DEVELOPMENT ASSESSMENT CASE NUMBER: CD-2022-0002 – 311-315 South Congress PUD

COMMENT REPORT

PROJECT NAME: 311 - 315 South Congress PUD

LAND USE PLAN

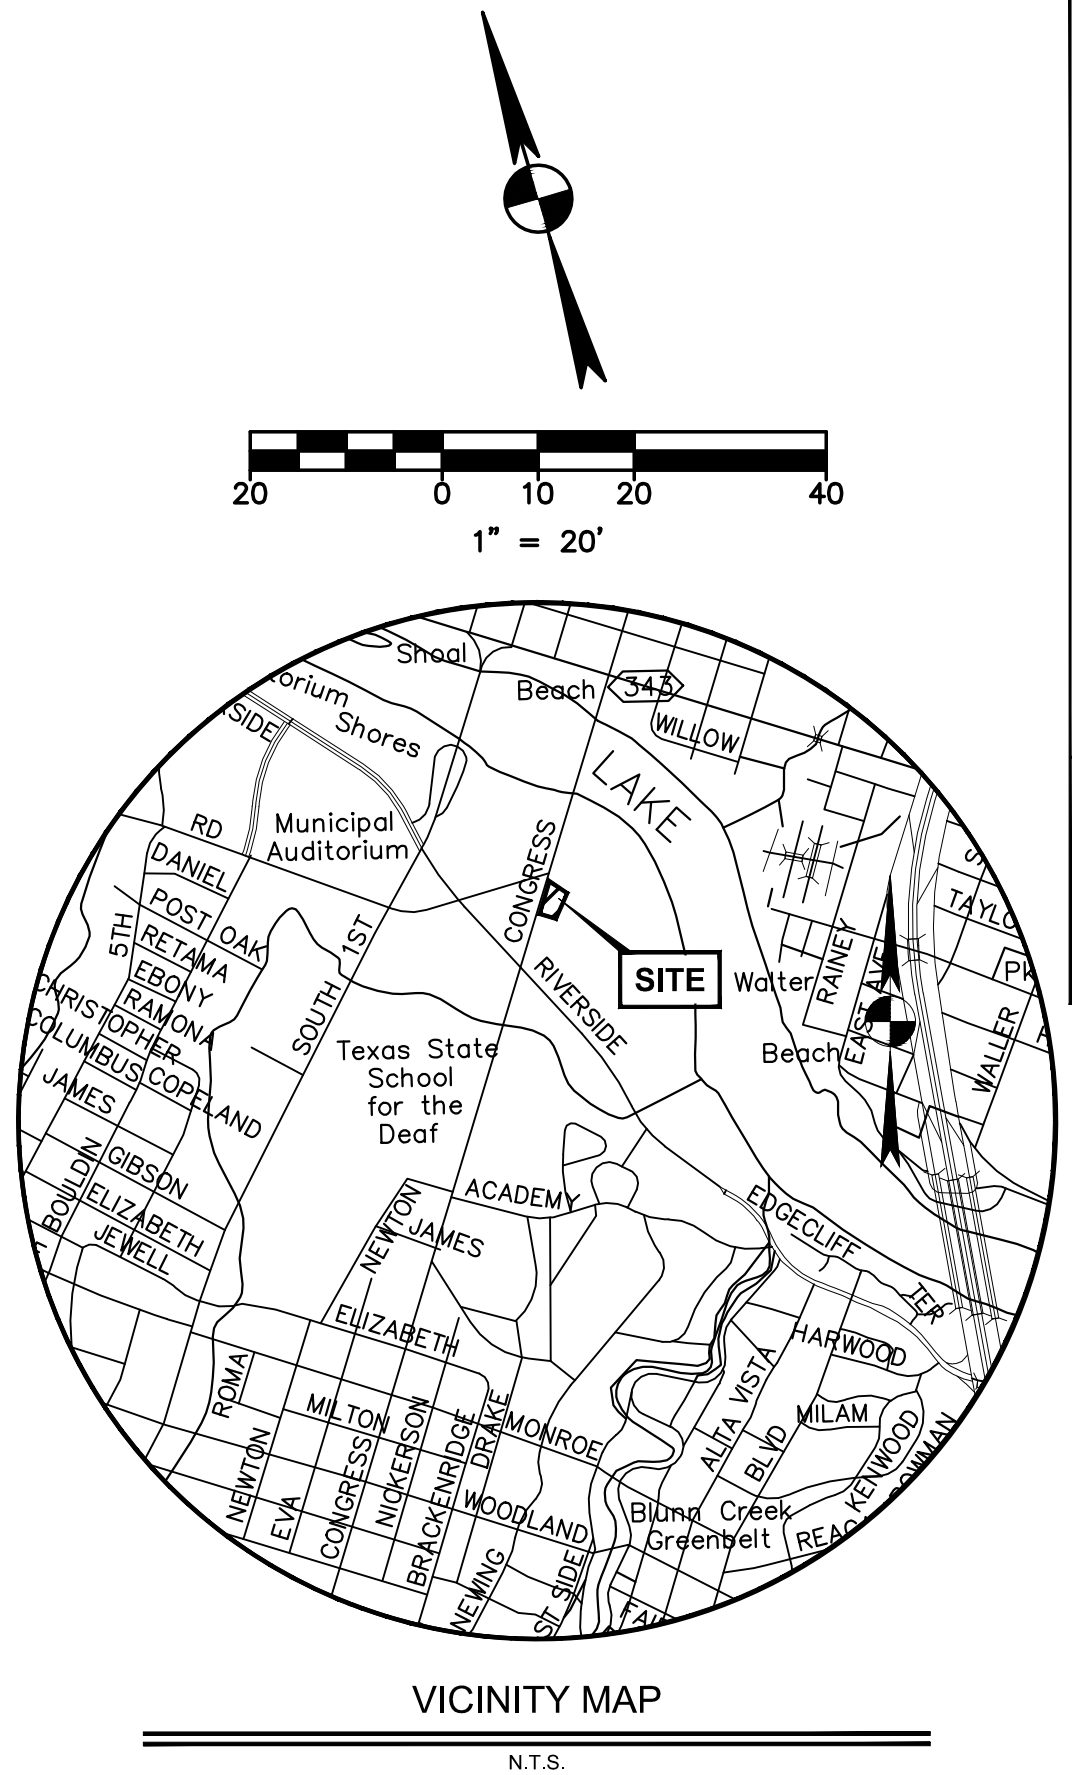
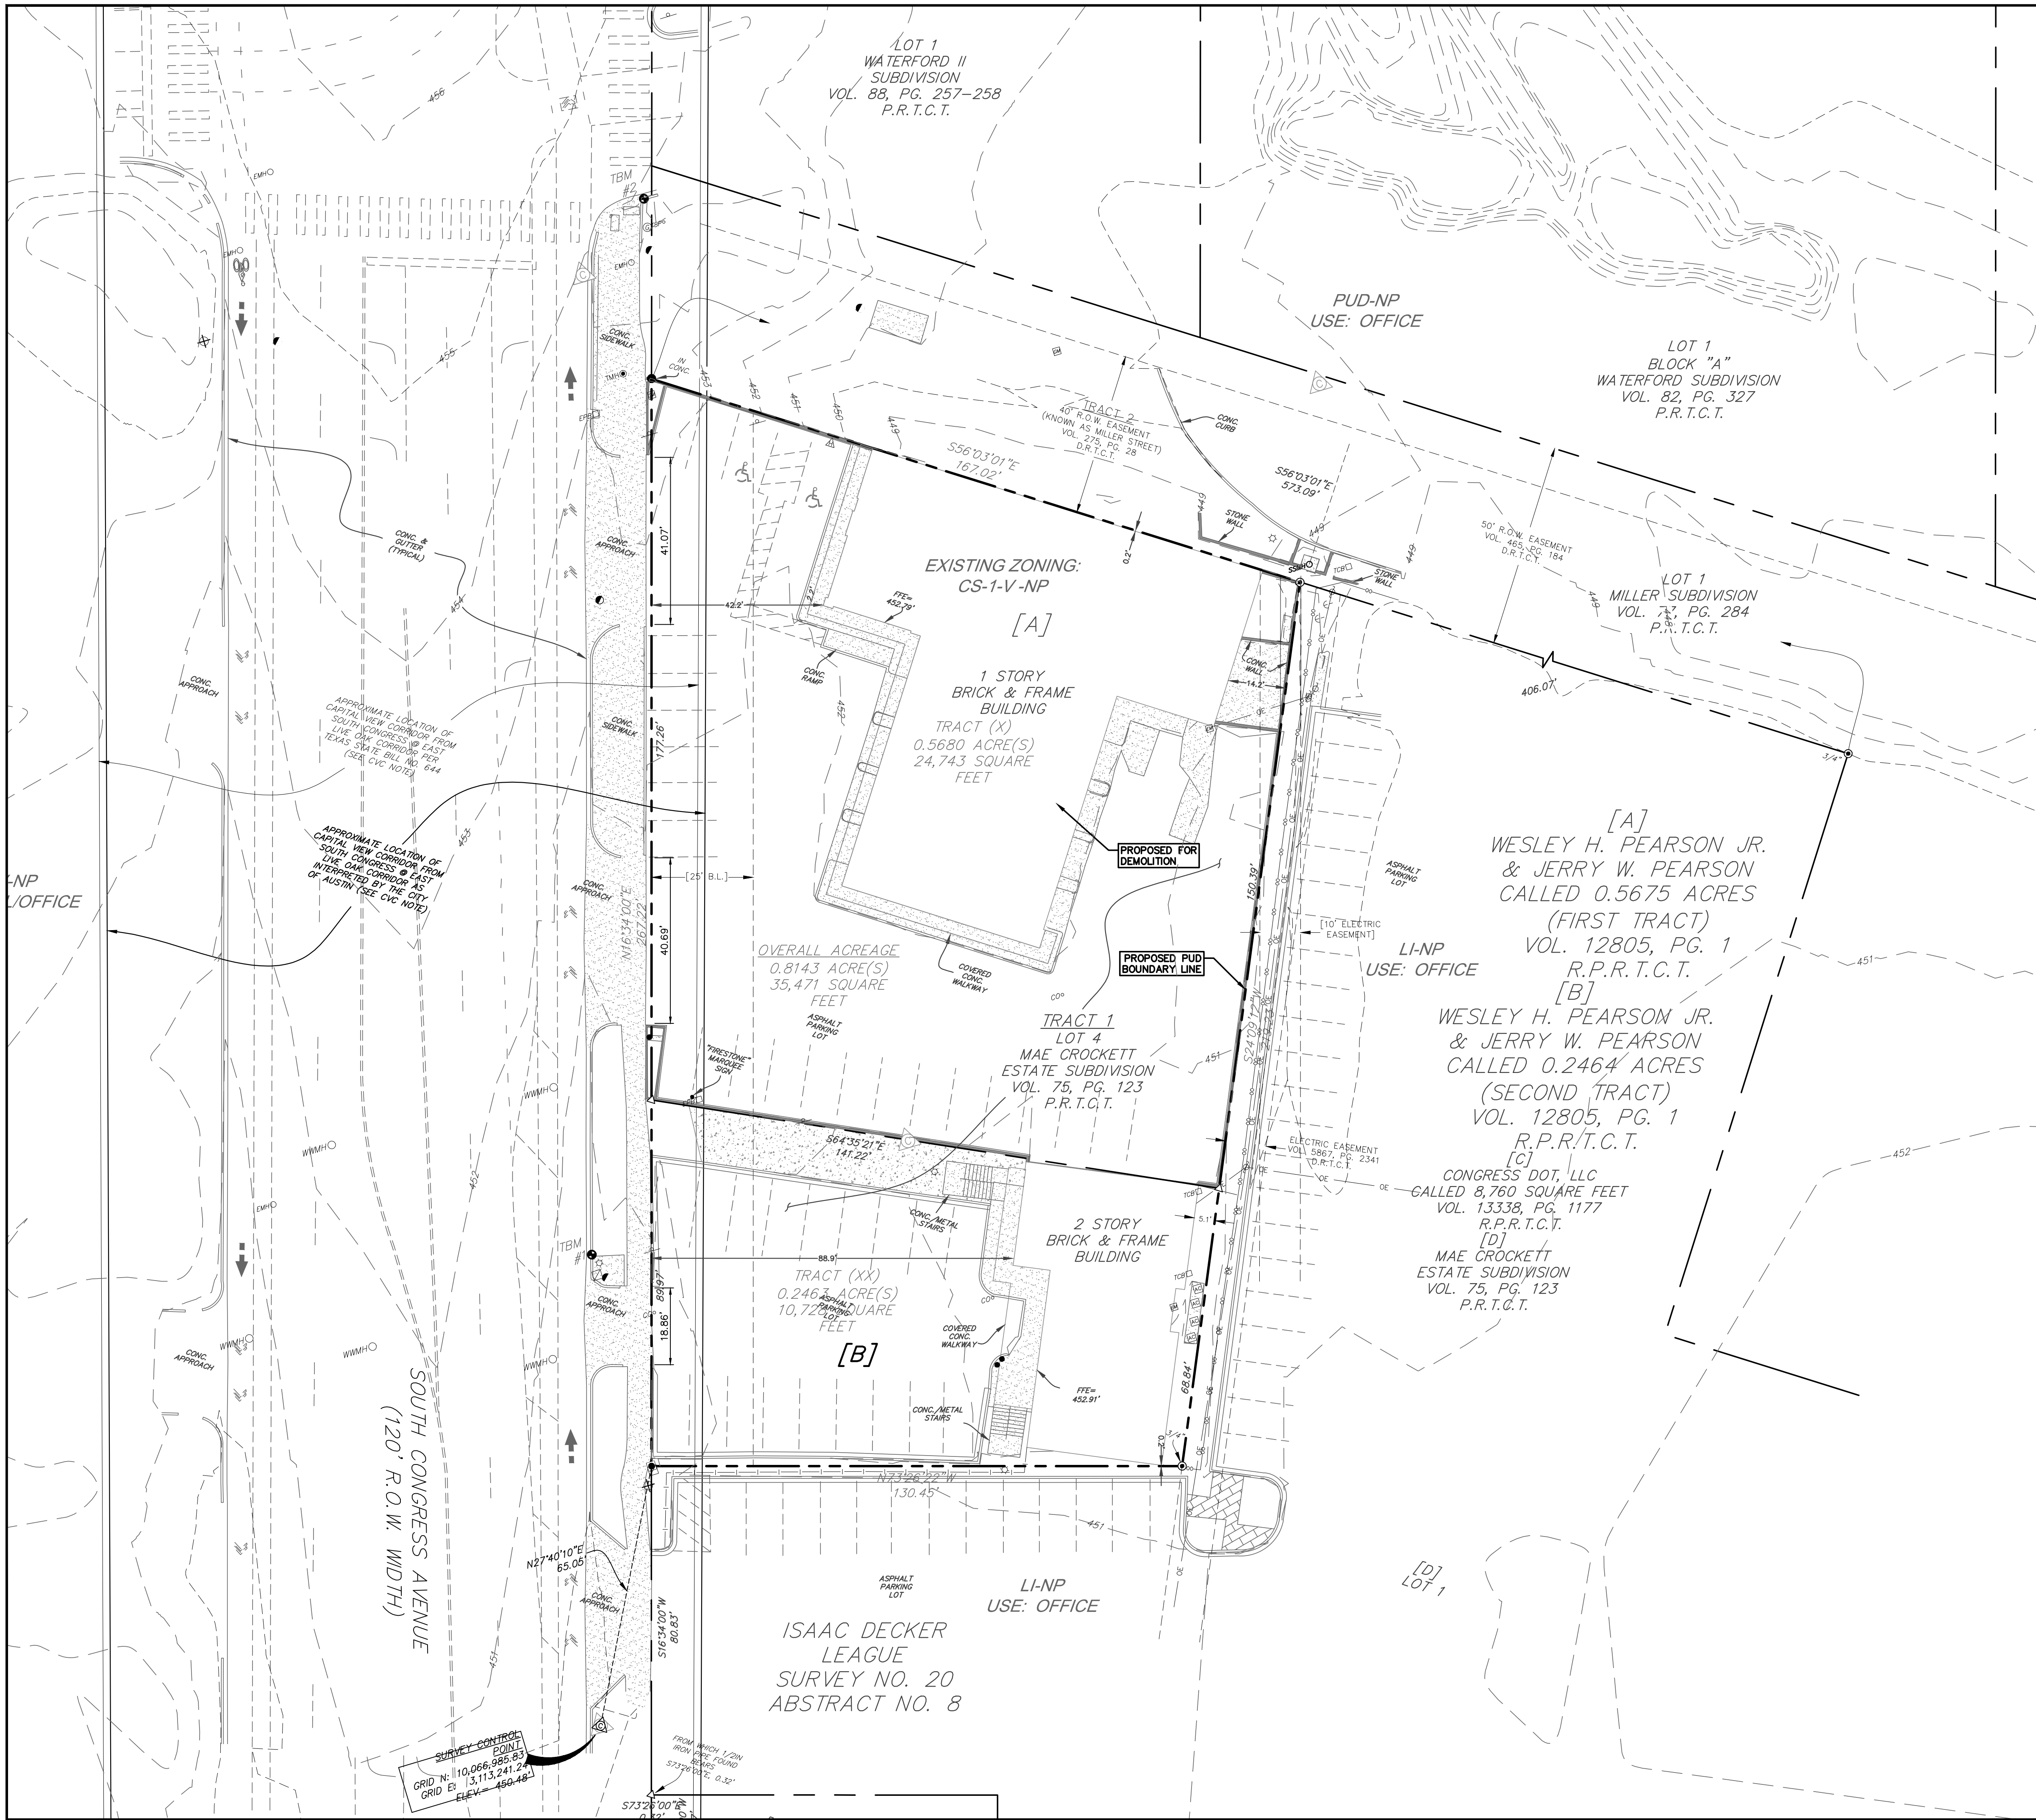
ZN 3. Add proposed Land Use Summary table that includes proposed uses (residential, office, and ground floor pedestrian-oriented use) and corresponding square footages to the Land Use Plan.

TREE LIST	
NUMBER	DESCRIPTION
5000	17" LIVE OAK
5001	8" LIVE OAK
5002	9" LIVE OAK
5003	15" LIVE OAK
5004	13" ASH
5005	33" ASH
5006	23" ASH

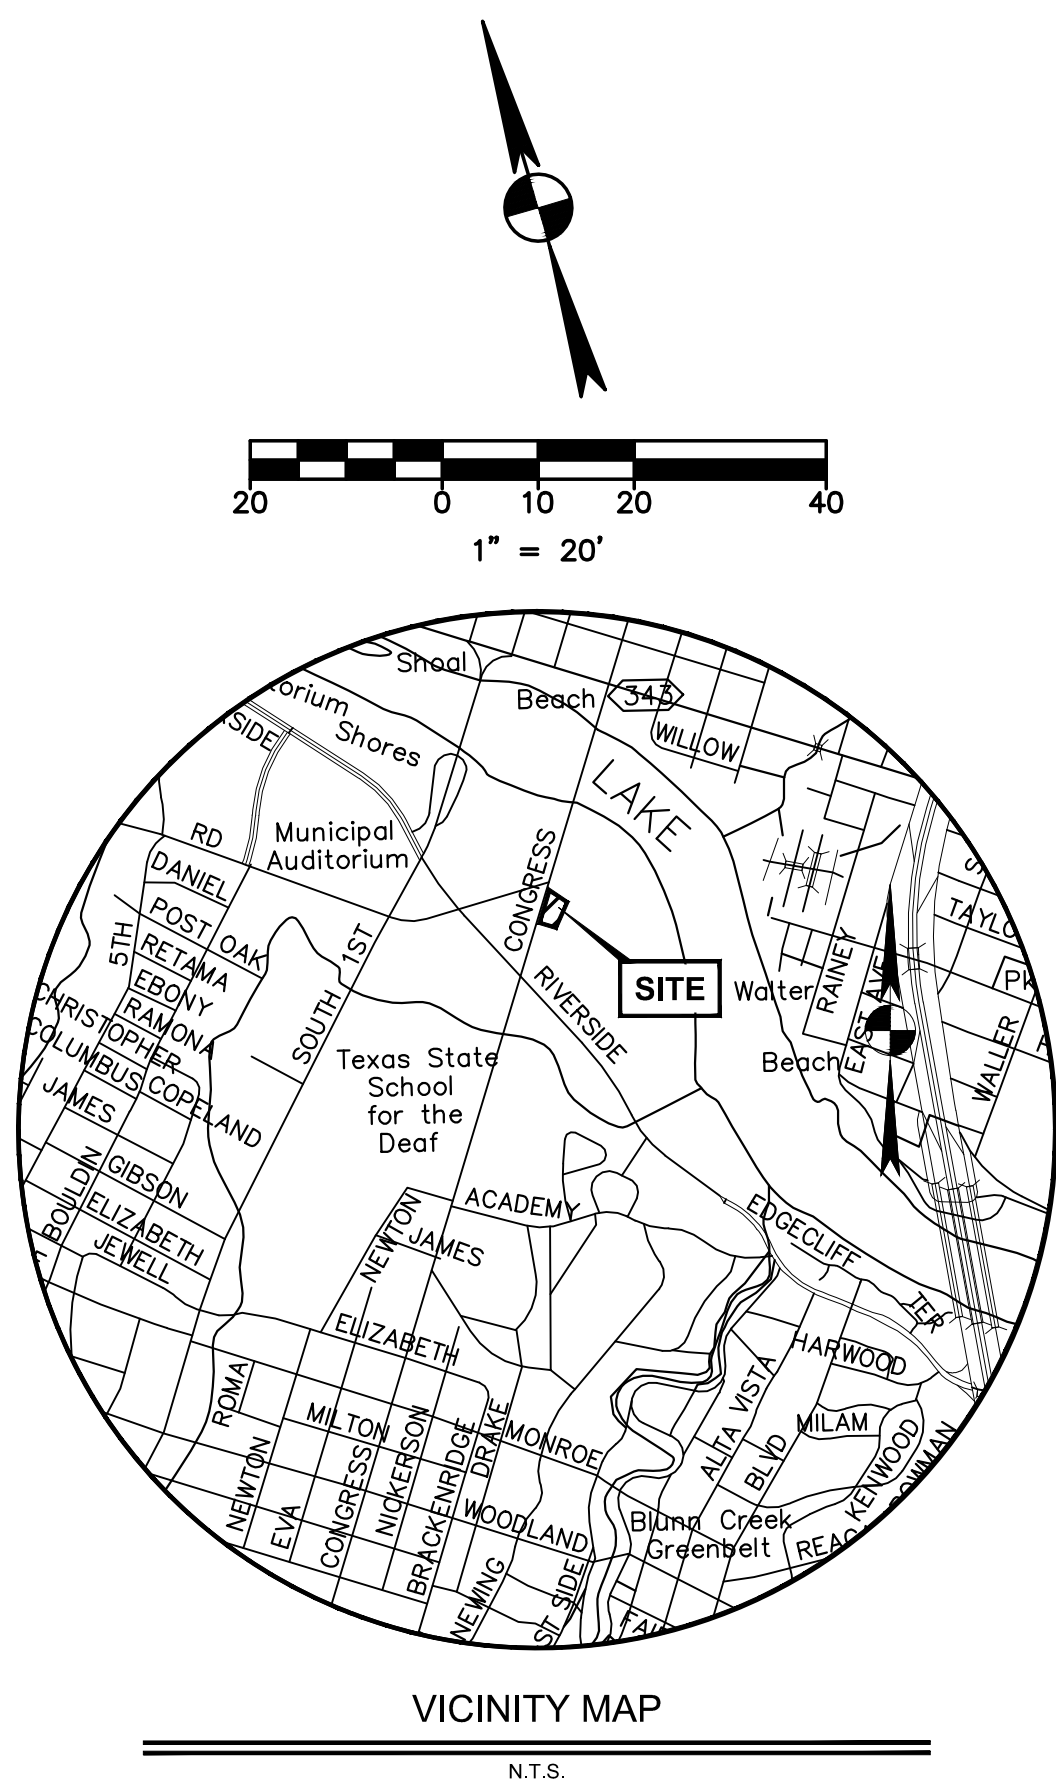
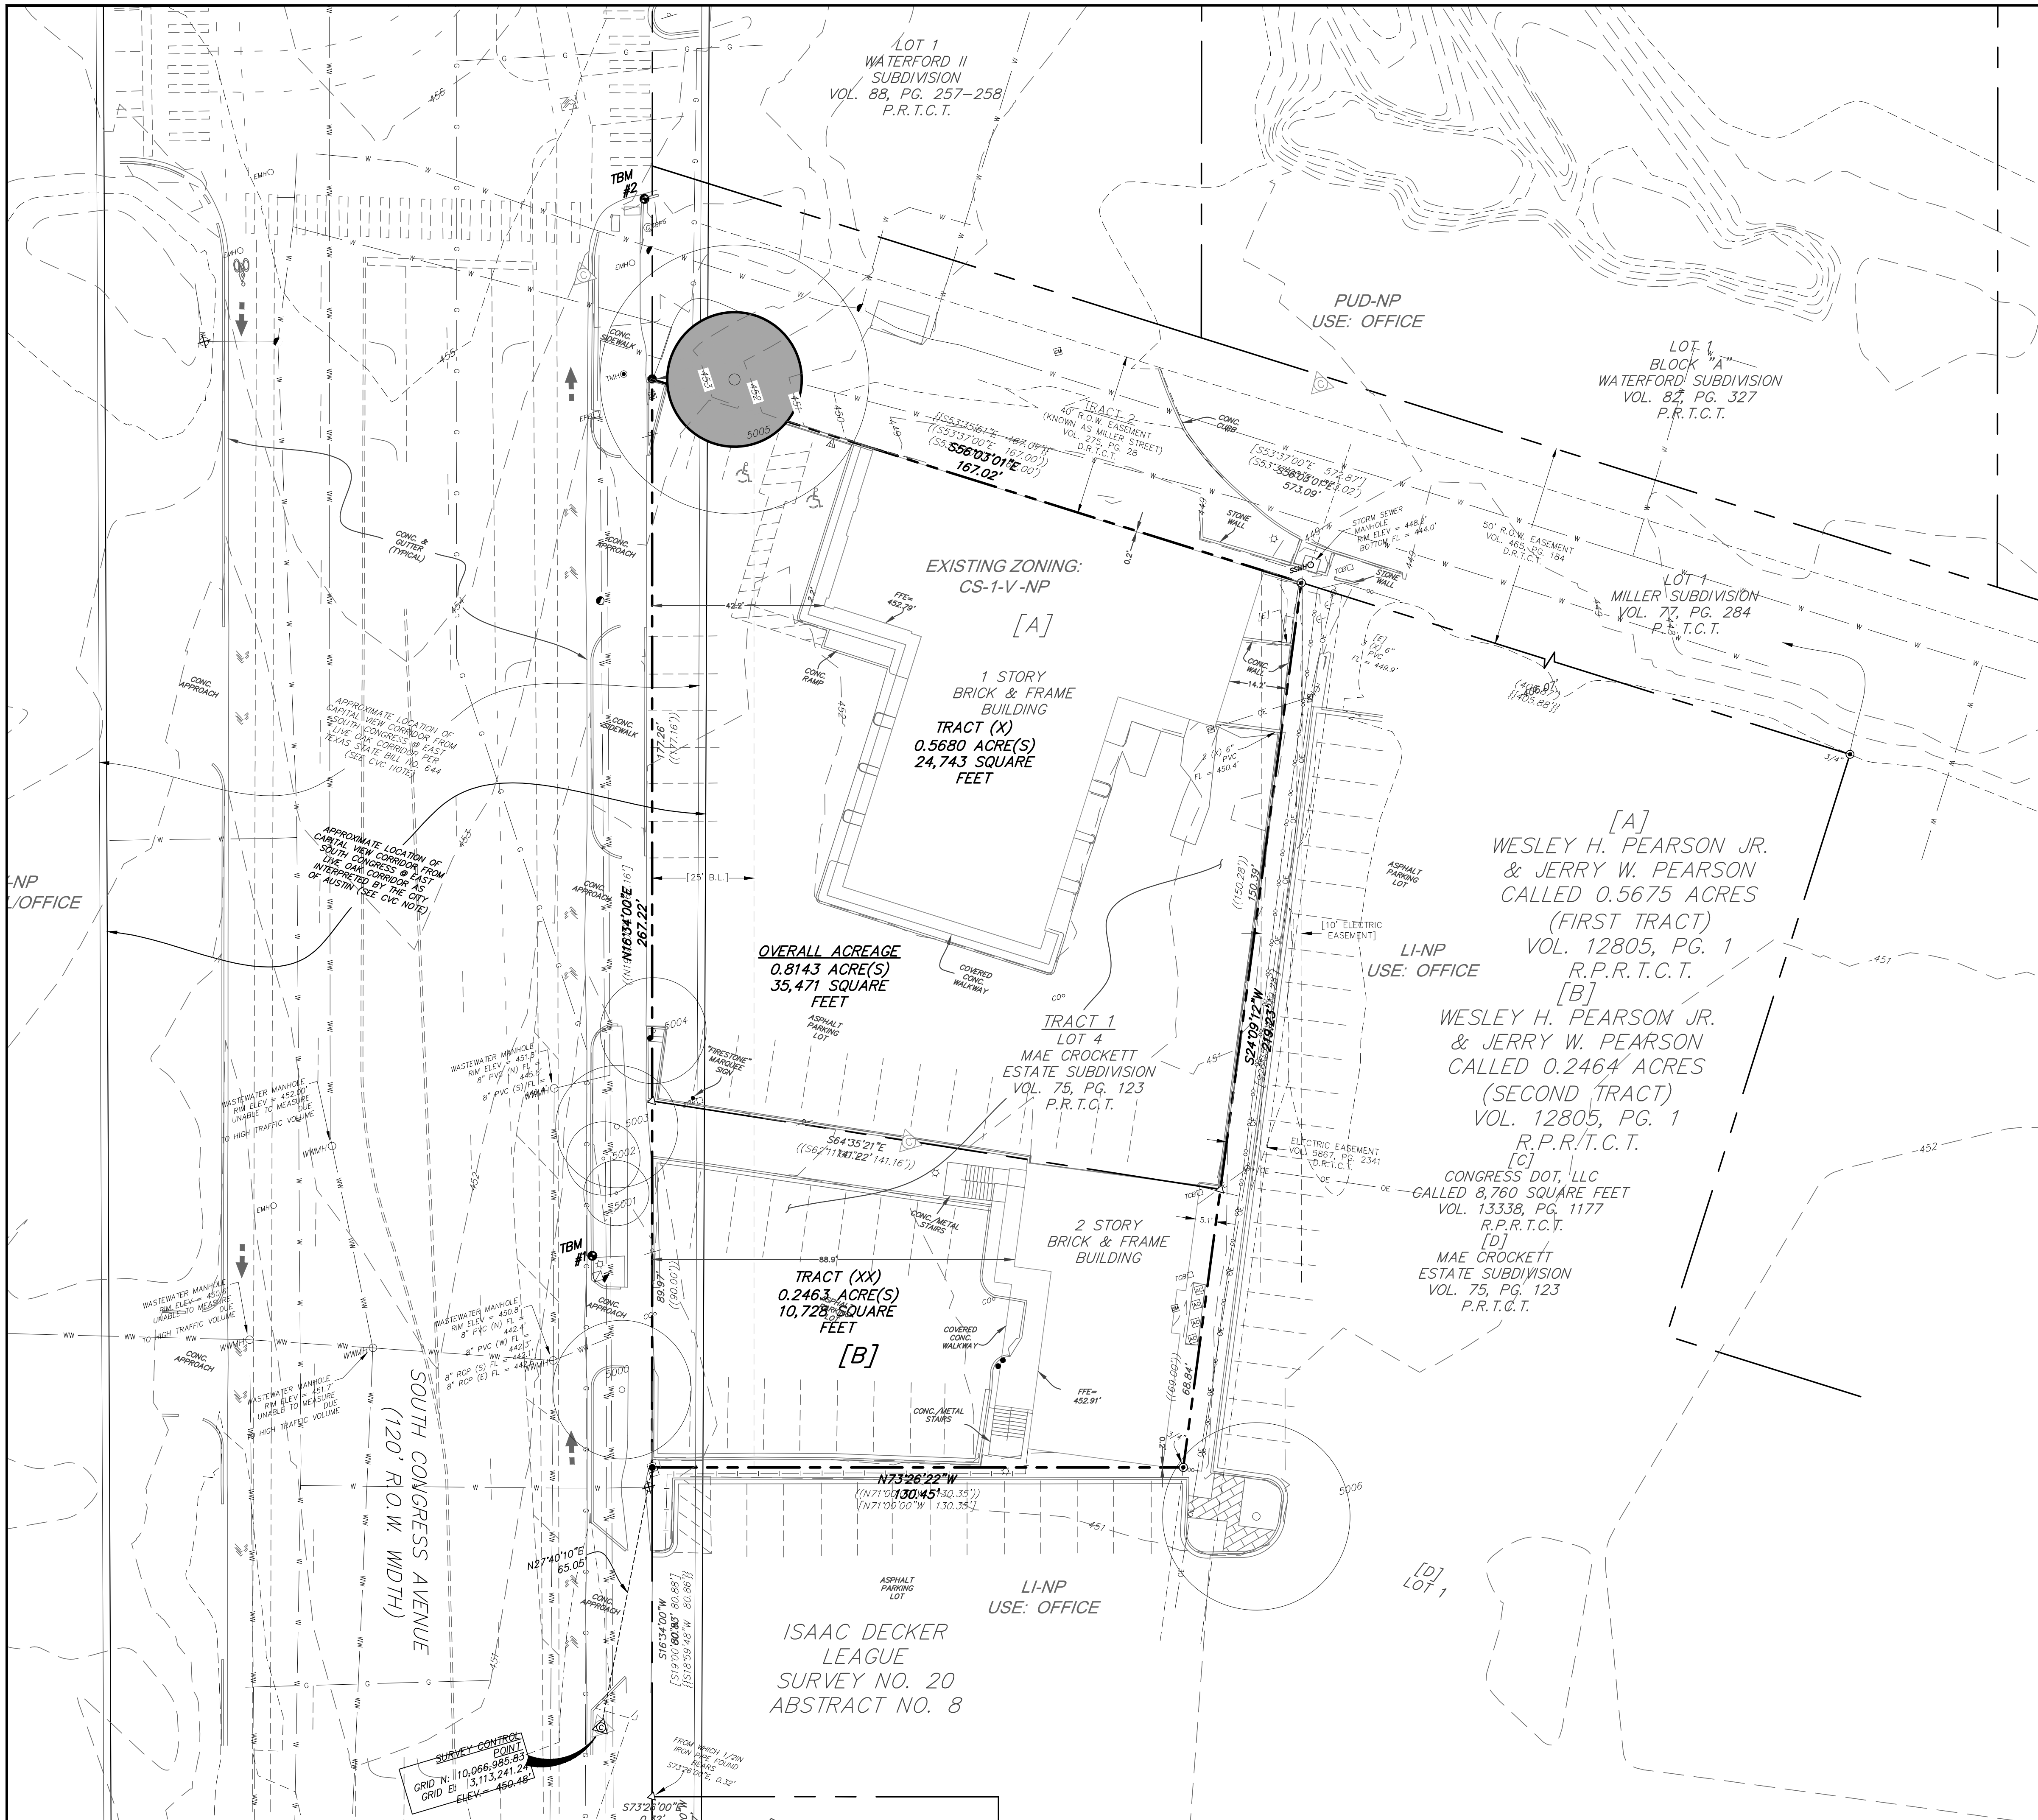
- CA 5 Please clarify the tree survey as Tree 5005, a 33” Arizona ash. The City has previously issued a dead diseased imminent hazard tree permit for its removal.
